RE: WILSON COUNTY MSWLF TRANSITION PLAN
REVISONS TO REPORT & SUBMITTALS

RE: WILSON COUNTY MSWLF TRANSITION PLAN
RESPONSE TO COMMENTS

RE: WILSON COUNTY MSWLF
REQUEST TO AMEND FACILITY BOUNDARY
EXPANDED BUFFER ZONE

WILSON COUNTY LANDFILL

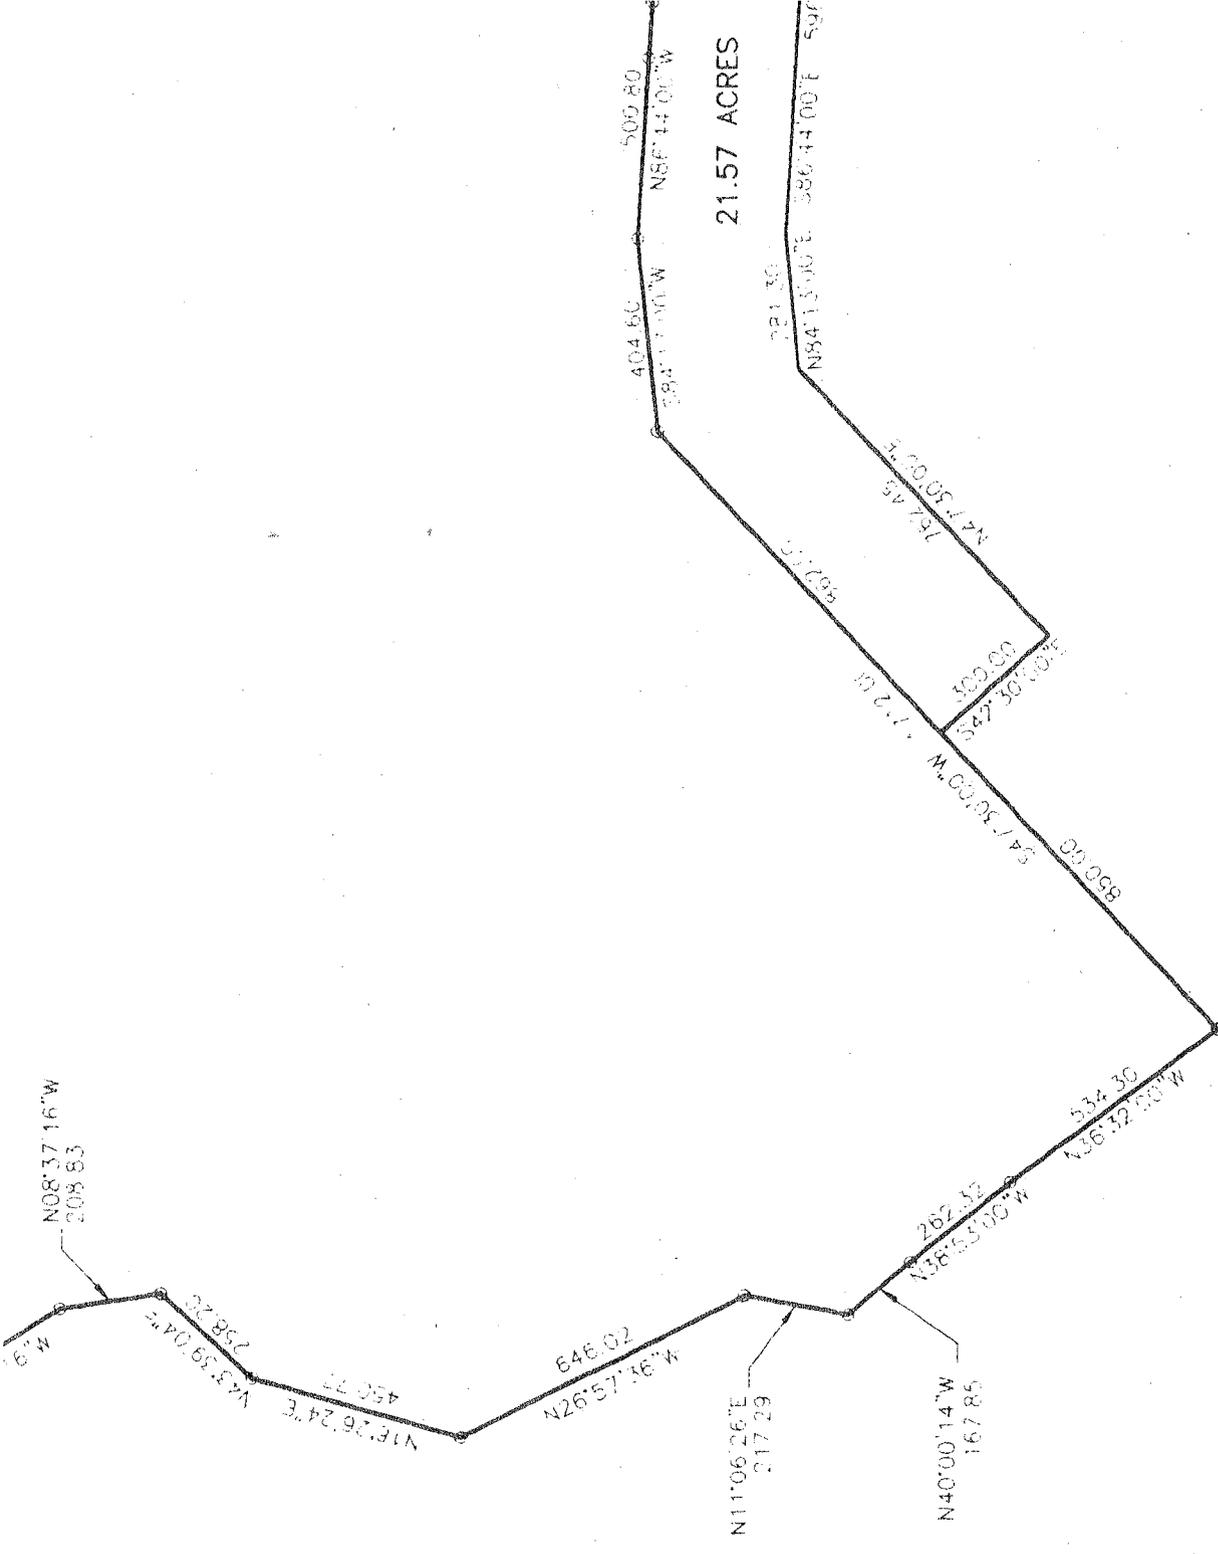
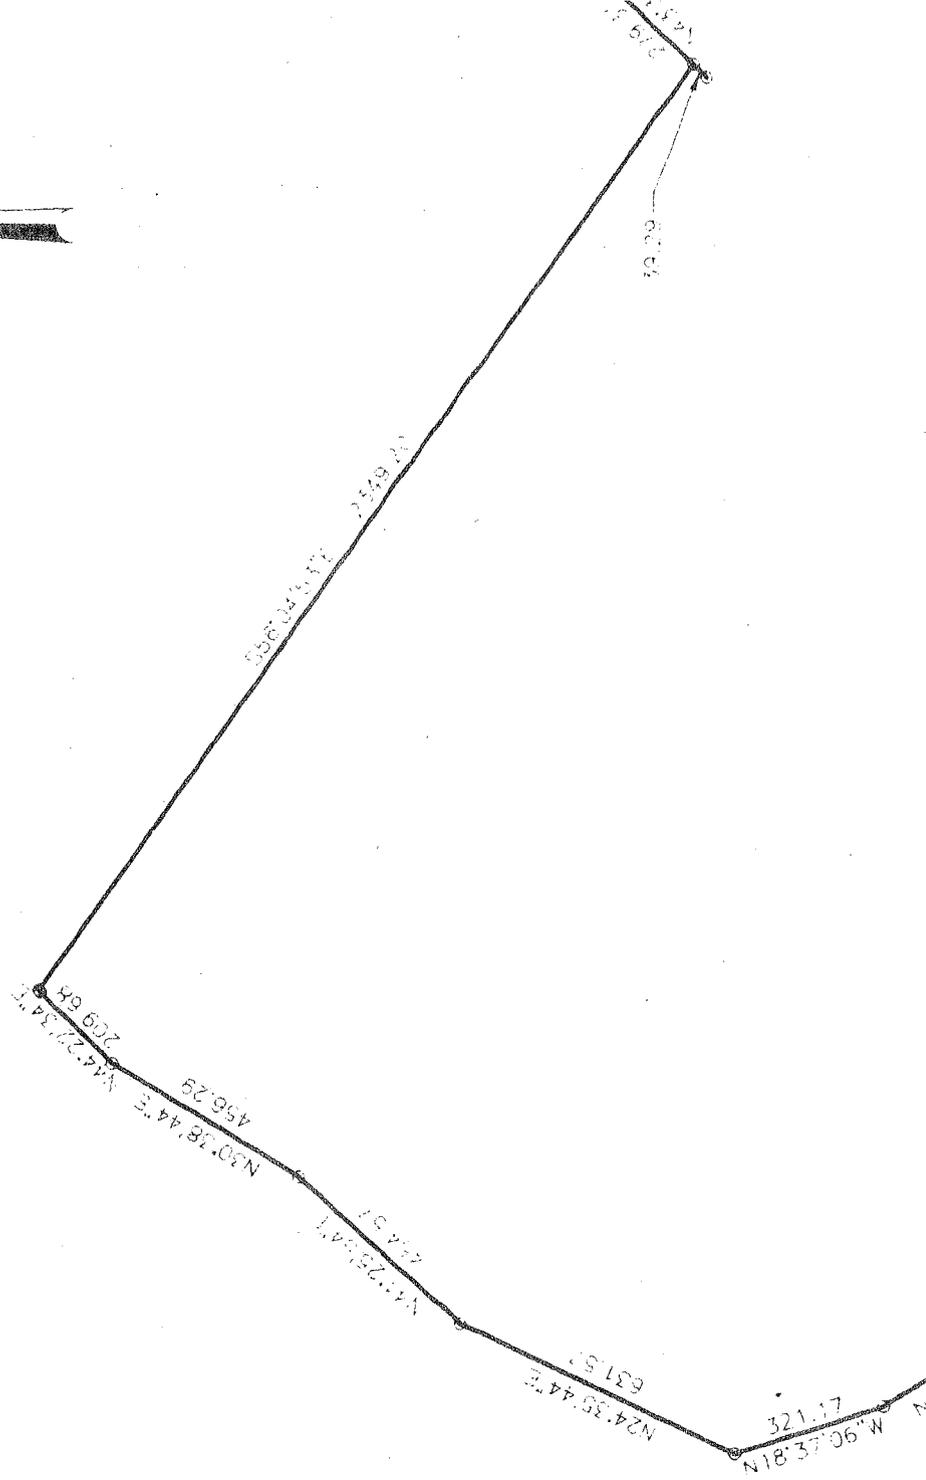
In order to expand the buffer zone between the MSWLF unit and the facility boundary, Wilson County is requesting that the 21.57 acre property described on the attached plat be included in the legal description of the permitted facility. This property is owned by the County and will provide an expanded physical separation from adjacent properties and is integral to compliance with 15A NCAC 13B. Currently, proposed activities in the buffer zone include well installations for groundwater and explosive gas monitoring, and limited grading.
